Access Compliance Report

Public Rights-of-Way

(Curb Ramps)

Intersection ID: 11109	Main Street: COLEBROOK_RD	Cross Street: MEADOWCLIFF_DR	Location: E
ADA ID: E542A4F2DD06	Ramp Type: BlendTrans1	Initial Pass/Fail: Fail	Overall Compliance: No
Severity Score: 8.75			
Codes/Mitigation Info/Possible Solution		Field Measurements/Component Compliance

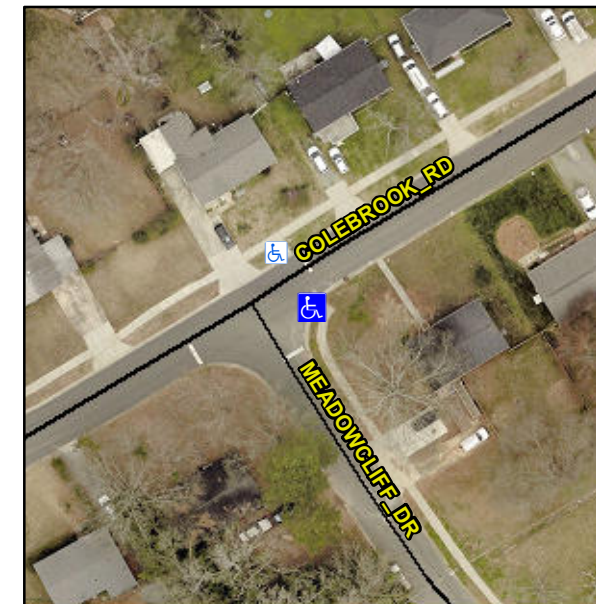
Not Found, R304.5.1

Compliance	Description	Data	Compliance	Description	Data
N/A	Ramp Length (in)	51.5	Yes	BlendTrans Slope (%)	2.9
No	Ramp Width (in)	47.0	Yes	BlendTrans XSlope (%)	0.1
N/A	Flare Type LT	N/A	N/A	Flare Type RT	N/A
N/A	Flare Slope LT (%)	N/A	N/A	Flare Slope RT (%)	N/A
N/A	Flare Traversable LT?	N/A	N/A	Flare Traversable RT?	N/A
N/A	Landing Length (in)	N/A	N/A	DWS Provided?	N/A
N/A	Landing Width (in)	N/A	N/A	DWS Contrast?	N/A
N/A	Landing Slope (%)	N/A	N/A	DWS Length (in)	N/A
N/A	Landing X Slope (%)	N/A	N/A	DWS Full Width?	N/A
N/A	Landing Curb? (Y/N)	N/A	N/A	DWS Offset (in)	N/A
N/A	Shared Landing?	N/A			
N/A	Gutter Ponding?	N/A	N/A	Gutter Slope (%)	N/A
N/A	Gutter Lip Ht (in)	N/A	N/A	Gutter X Slope (%)	N/A
N/A	Painted X Walk1?	No	N/A	Painted X Walk2?	N/A
	X Walk 1 Direction	To NW		X Walk 2 Direction	N/A
	X Walk 1 Width (in)	N/A		X Walk 2 Width (in)	N/A
	X Walk 1 Slope (%)	1.8		X Walk 2 Slope (%)	N/A
	X Walk 1 X Slope (%)	1.4		X Walk 2 X Slope (%)	N/A

N/A	Ramp inside XWalk1?	N/A	N/A	Ramp inside XWalk2?	N/A
	Road Slope (%)	1.4		Clear Space?	N/A
	Road X Slope (%)	1.8	N/A	Clear Space to XWalk (in)	N/A
N/A	Any Obstructions?	N/A	N/A	Storm Grate/Utility Hazard?	N/A
	Obstruction Type			Storm Grate/Utility Type	
		N/A			N/A
			Yes	Surface Condition? (G/P)	Good
			No	Curb Slope (%)	5.2

Remove & Replace Curb Ramp With Two New Directional Ramps or Equivalent.
